October 20, 2017

RE: Comments on Draft Title V Air Operation Permit No. 10203T06 for Enviva Pellets Northampton, LLC, Northampton Wood Pellet Plant, Garysburg, Northampton County, North Carolina.

Graph 1. Projected emission factor at 10% softwood, based on AP-42 emission factors for 100% softwood and 50% softwood.

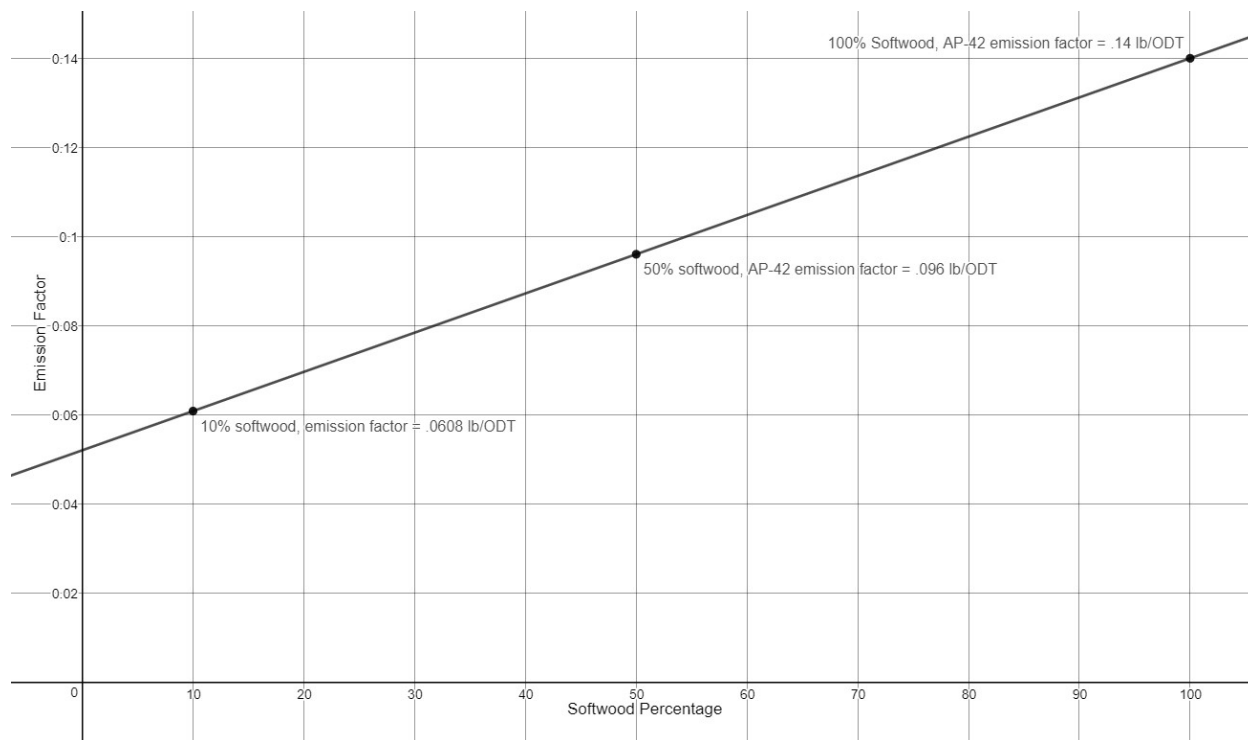
source categories are reduced from 4.7 lb/ODT to 1.6 lb/ODT, for a reduction of 65.96%. This shows that formaldehyde emissions do not decrease at the same rate as total VOCs, and instead decrease much more slowly. Furthermore, using this method to develop an emission factor for formaldehyde at 10% softwood produces a factor of .06 lb/ODT, as shown in the graph below:⁴⁷

This emission factor of .06 lb/ODT for 10% softwood, applied to Enviva Northampton’s initial dryer operation rate of 61.5 tph, results in 16.16 tpy of formaldehyde emissions from the dryer alone. This level of formaldehyde emissions is well above the major source threshold of 10 tpy for any single HAP, meaning the facility was a major source as originally permitted and operated.
